Freshwater Mixed Use Development

50 Lawrence Street
Freshwater, NSW

Development Application
SEPTEMBER 2021

LIST OF CHANGES:

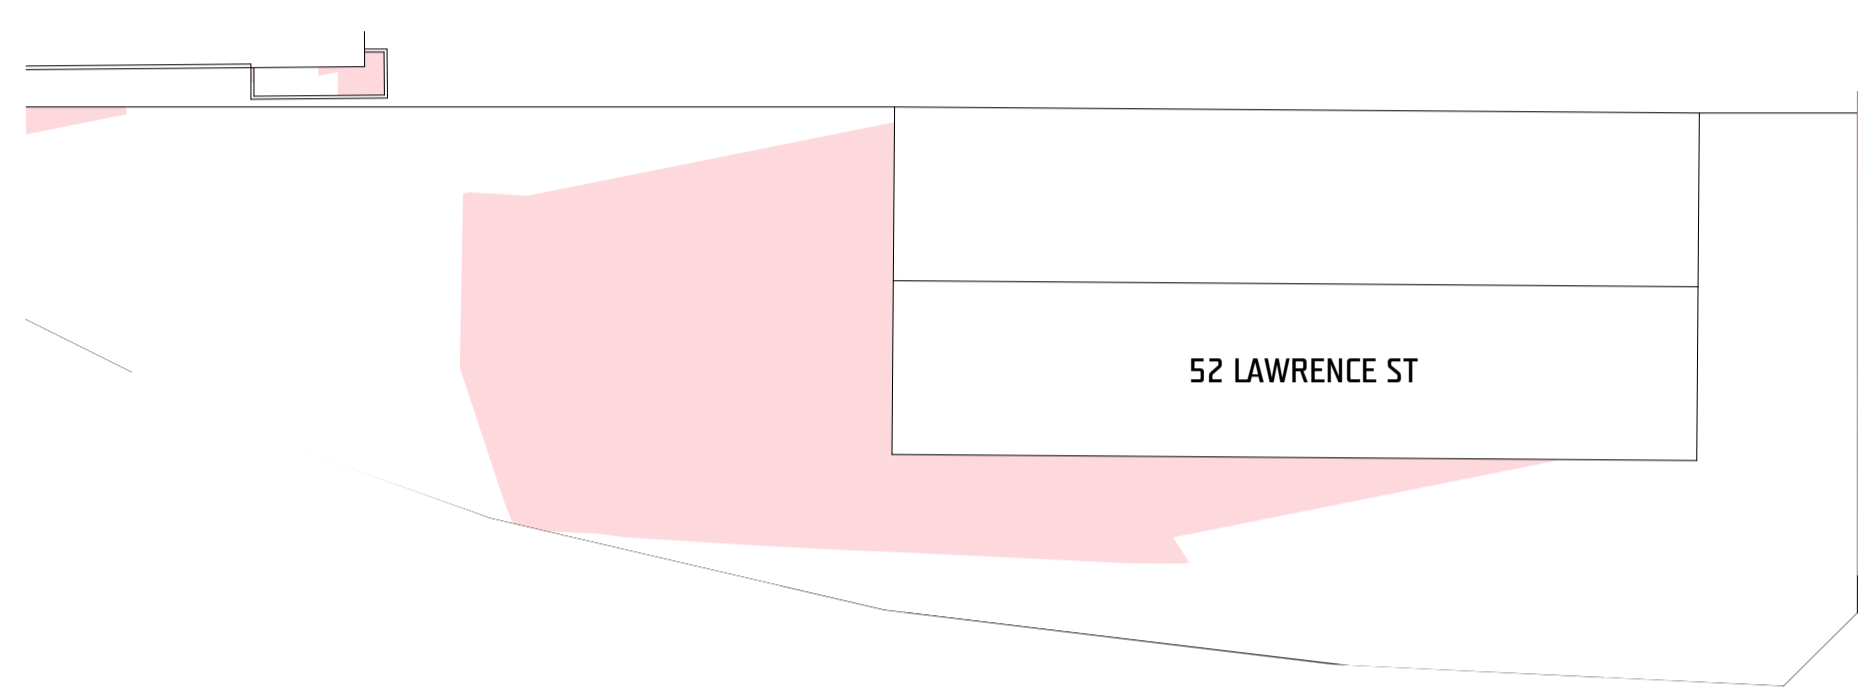
M: Neighbouring Property- Existing garage added to plans for clarity.

June Shadows 3pm
SCALE 1:250 @ A1

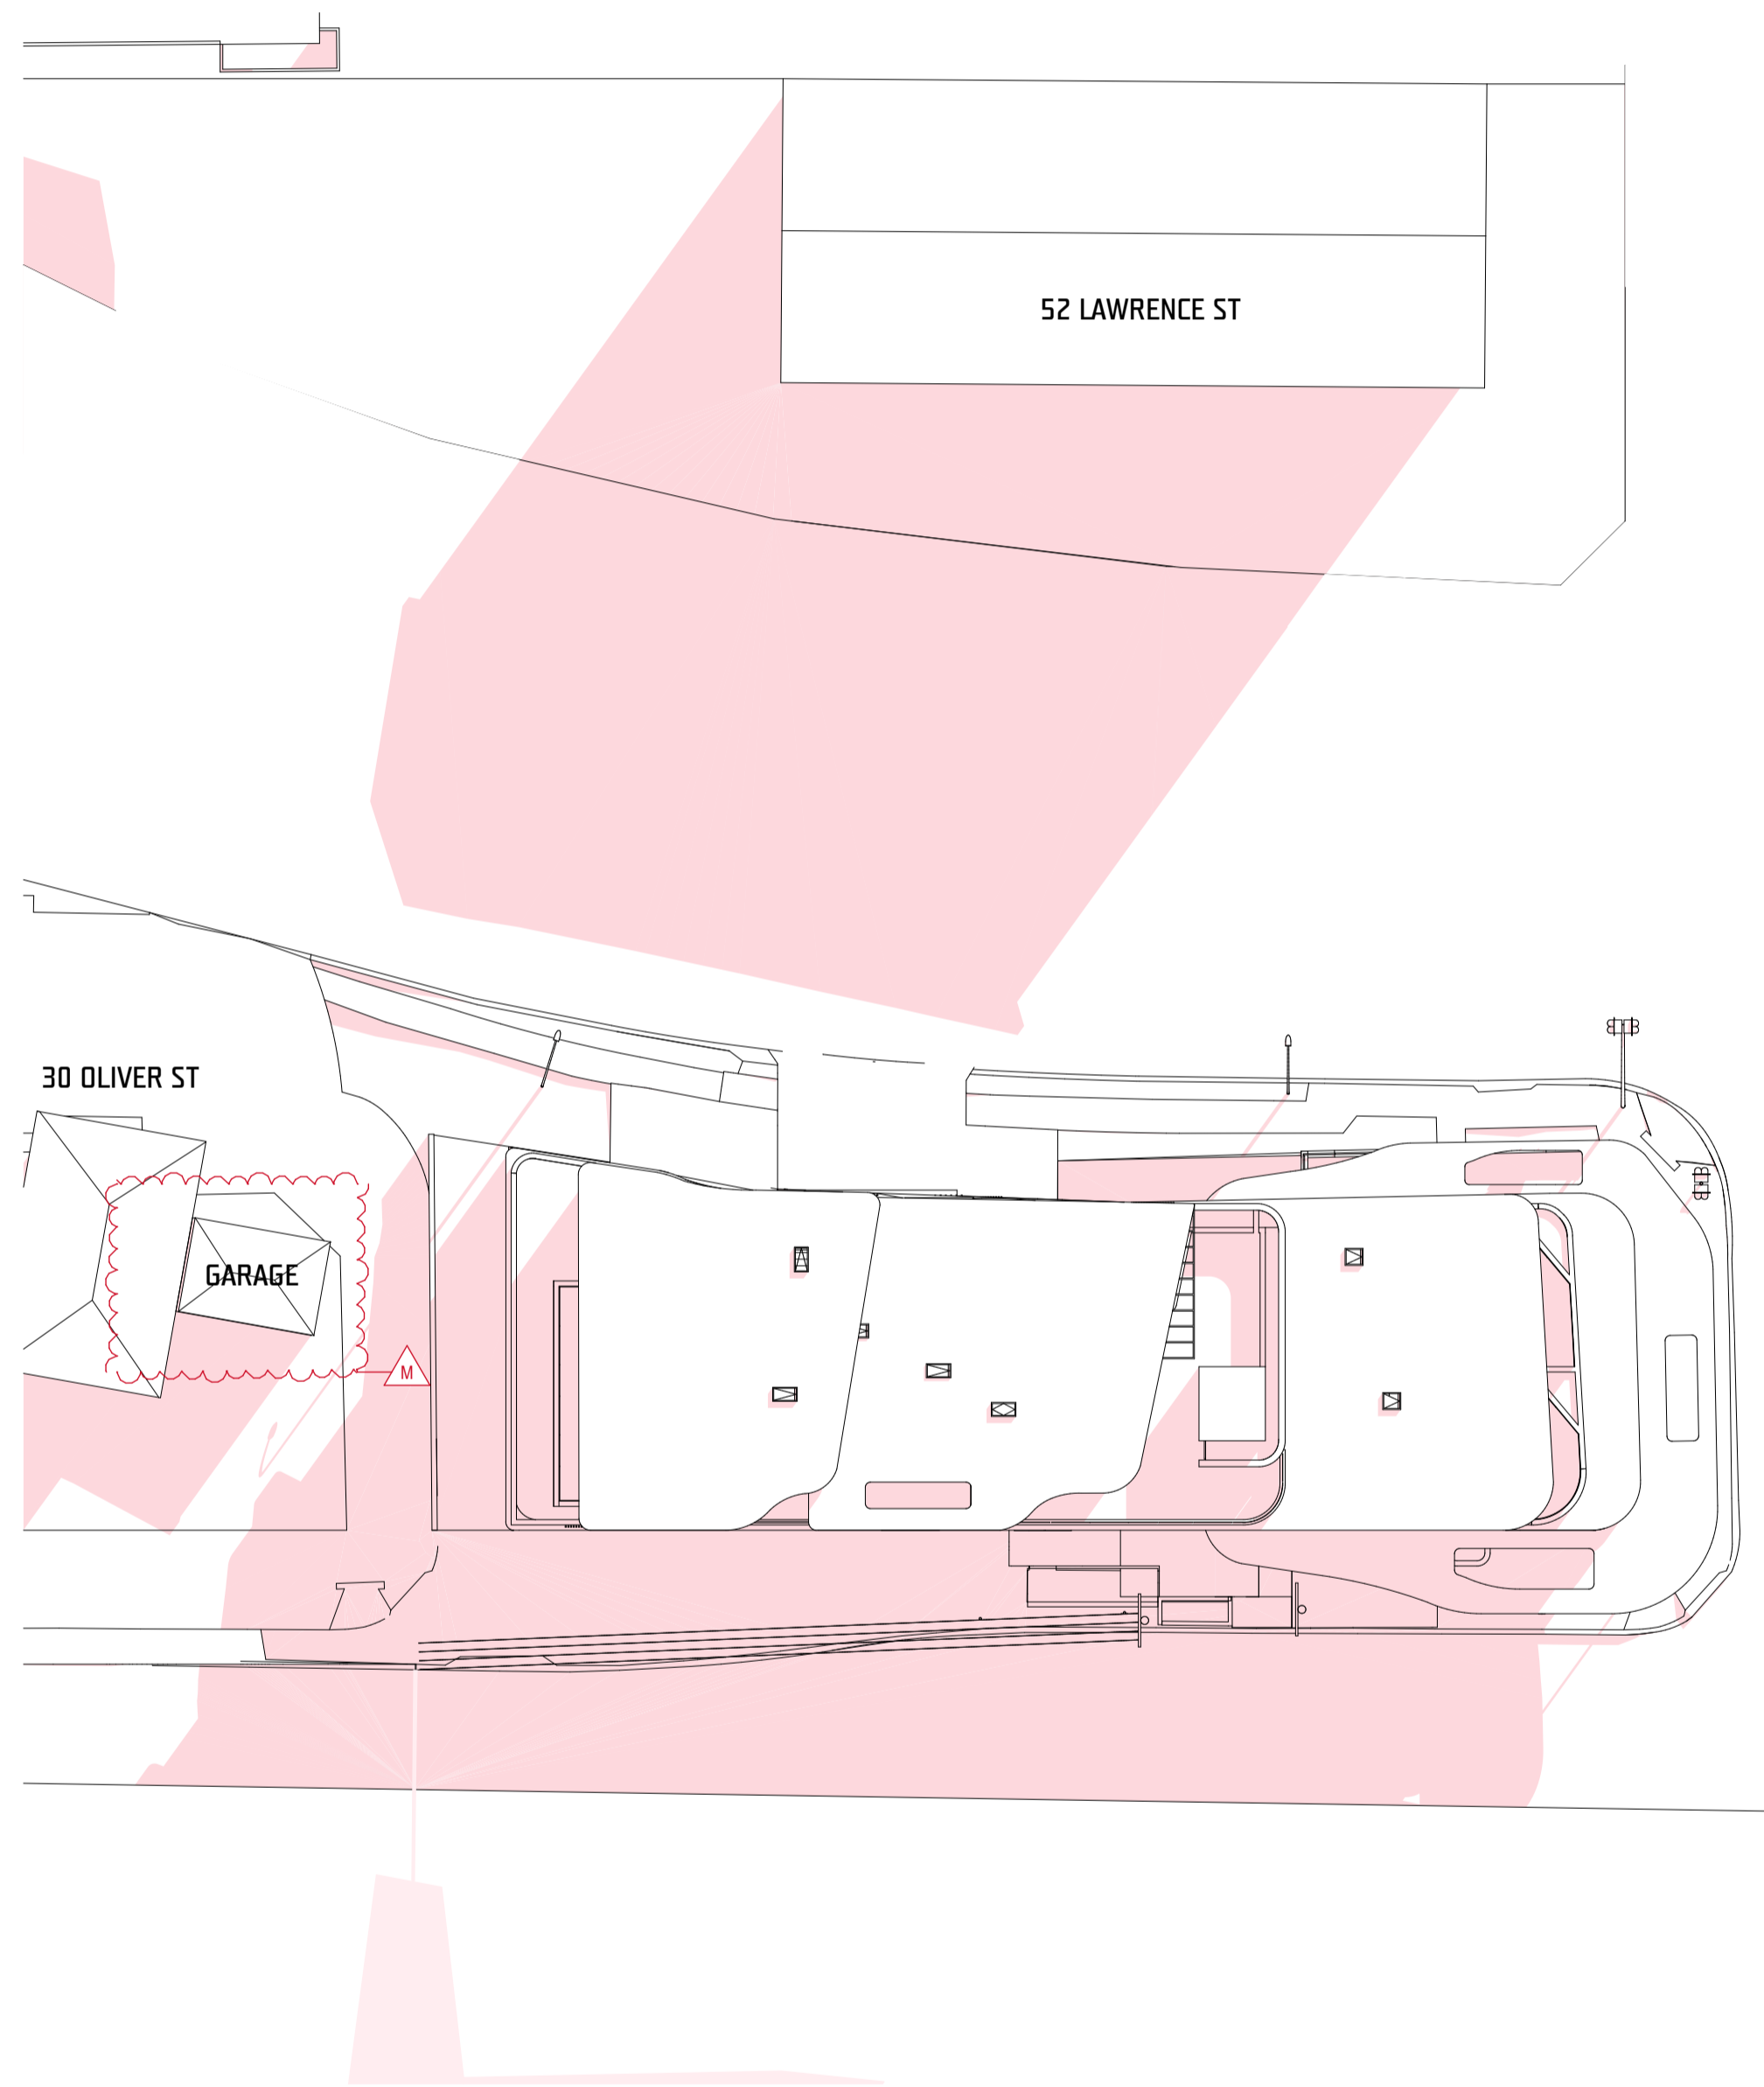
M: Neighbouring Property- Existing garage added to plans for clarity.
